DRAINAGE AND TRANSPORTATION INFORMATION SHEET

PROJECT TITLE: MORNINGSIDE LOFTS ZONE MAP/DRG. FILE # K-17-2
 DRB#: _____ EPC#: _____ WORK ORDER#: _____

GRADING AND DRAINAGE
PLAN

**Re: Morningside Lofts
3919 Silver Ave SE
Grading & Drainage Plan
Engineers Stamp Dated: 6/25/15 (K17D109)**

A1 GRADING AND DRAINAGE PLAN

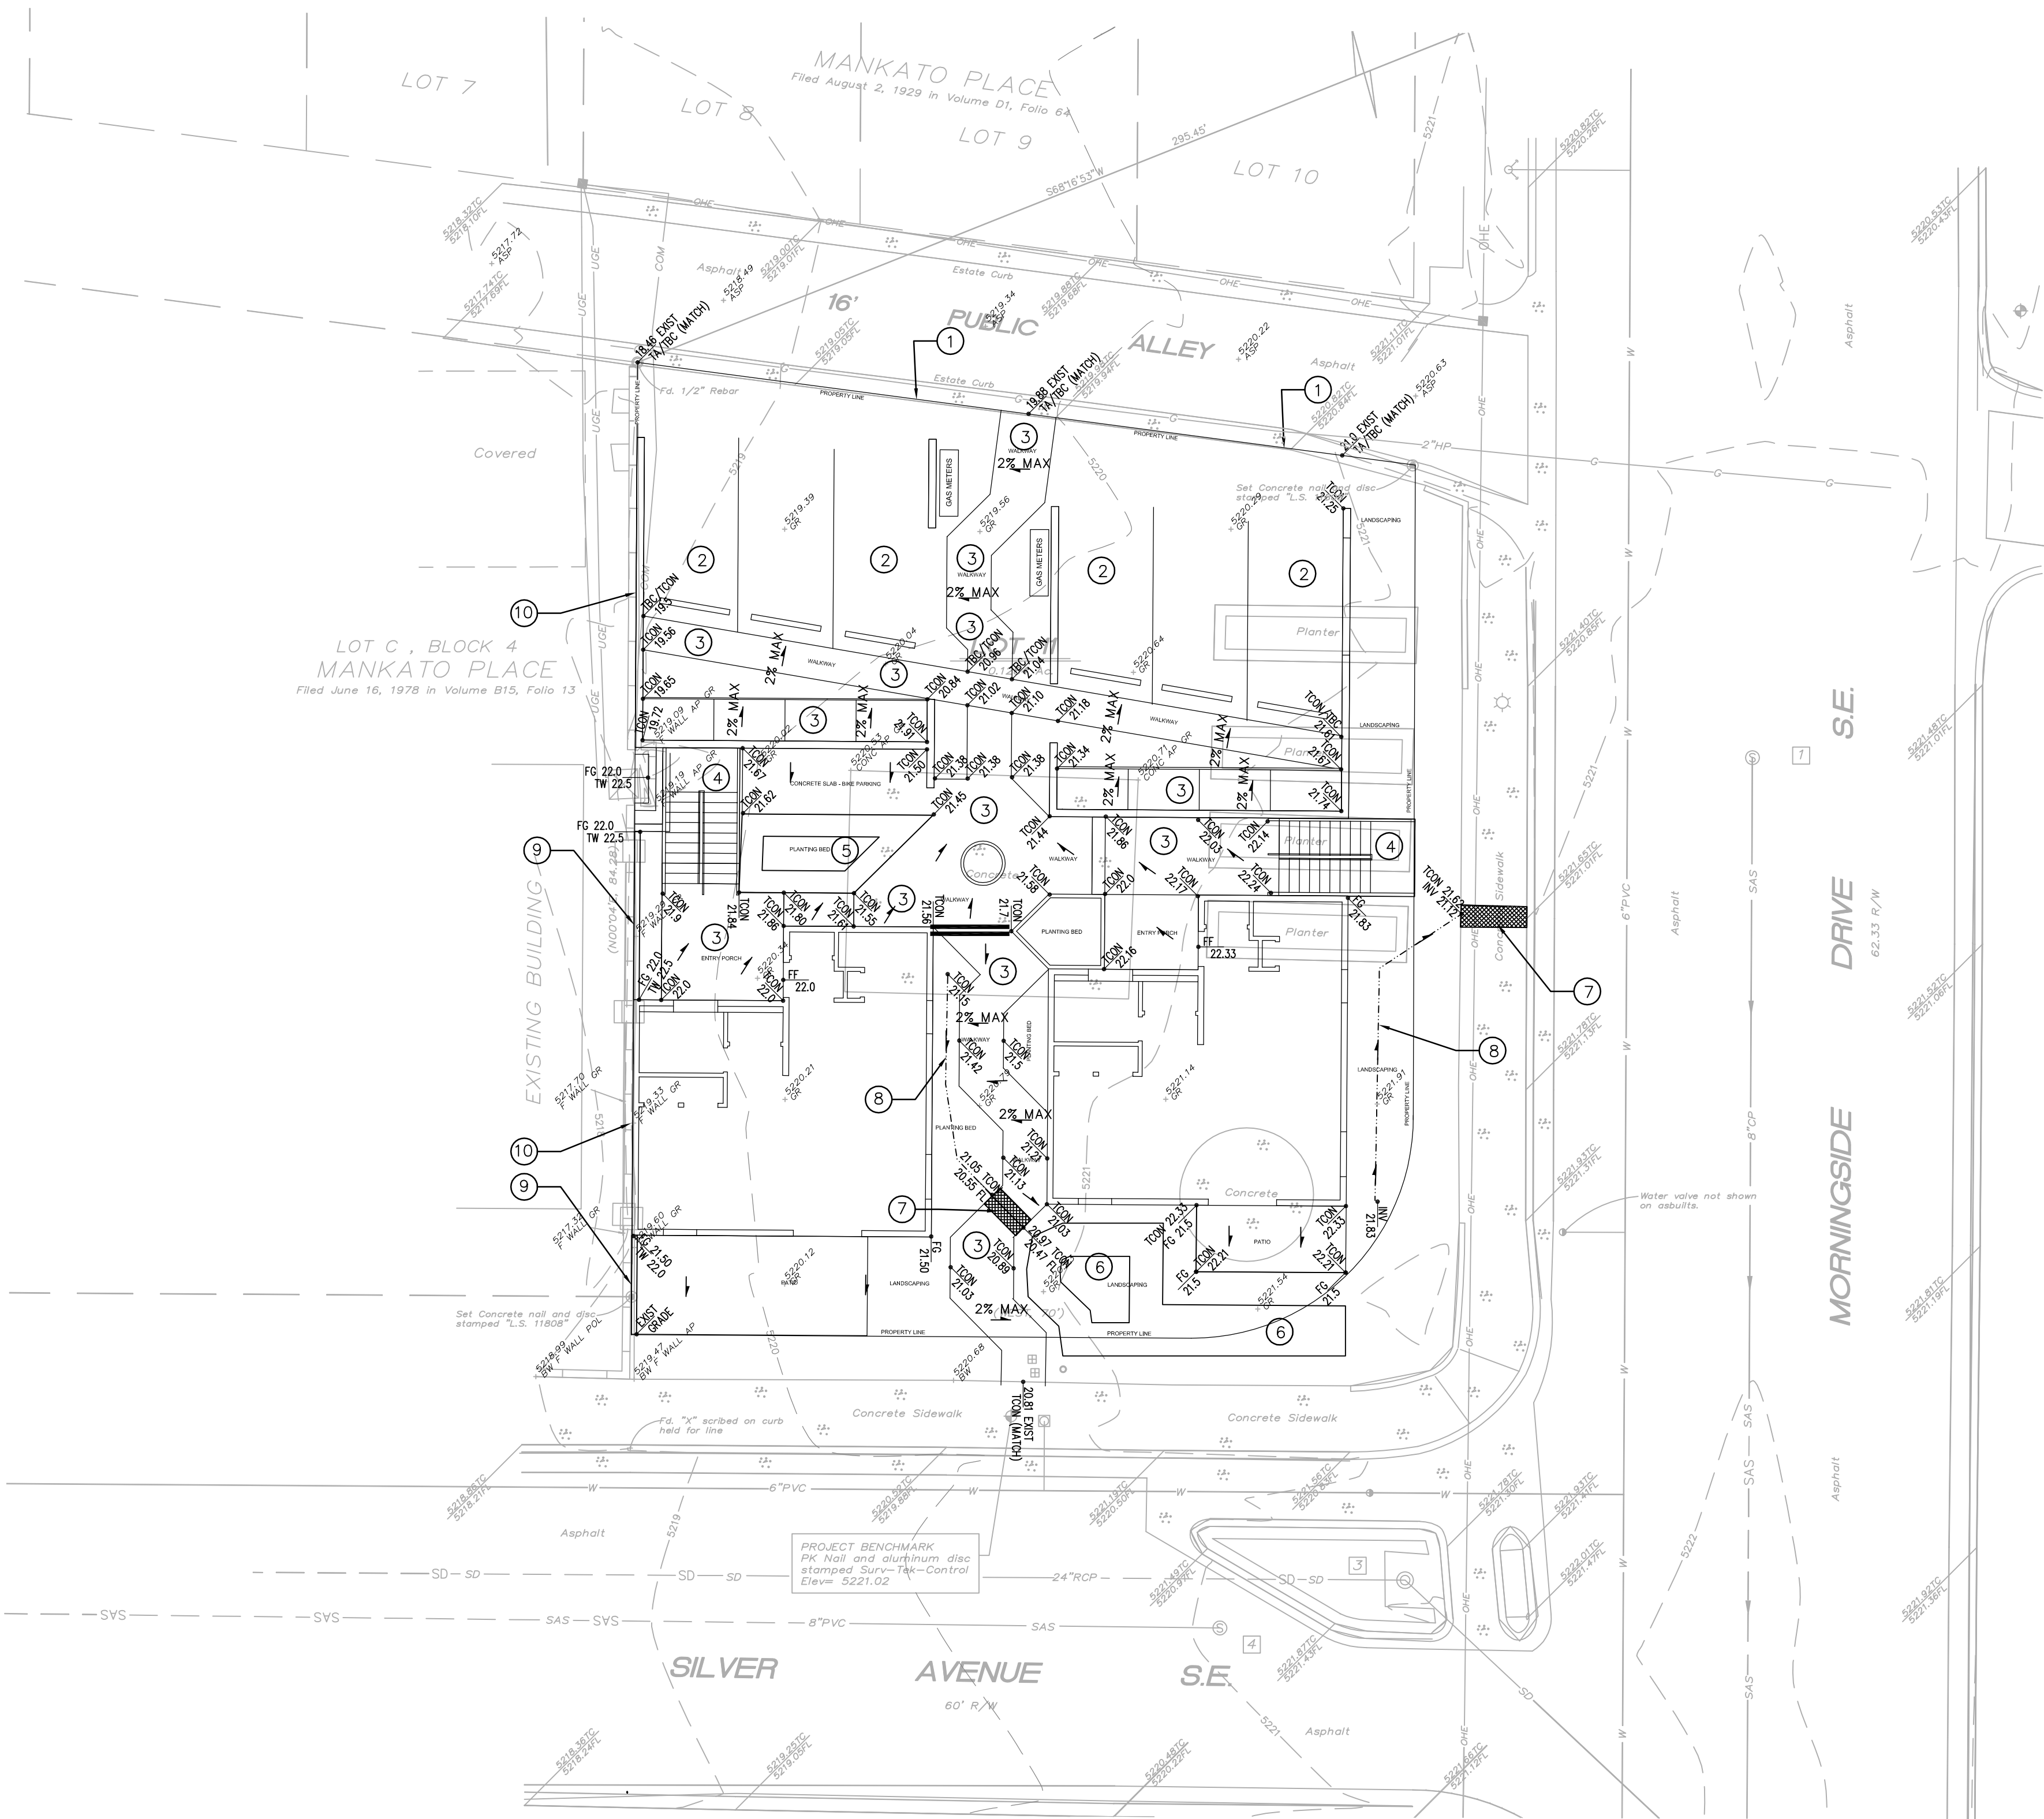
- Provide the roof flows. These flows must pass through the first flush ponds before exiting the site.
- Provide the Finished Floor.
- The sidewalk culvert must extend 2 feet inside the property line.
- The first flush pond must stay inside the property line.
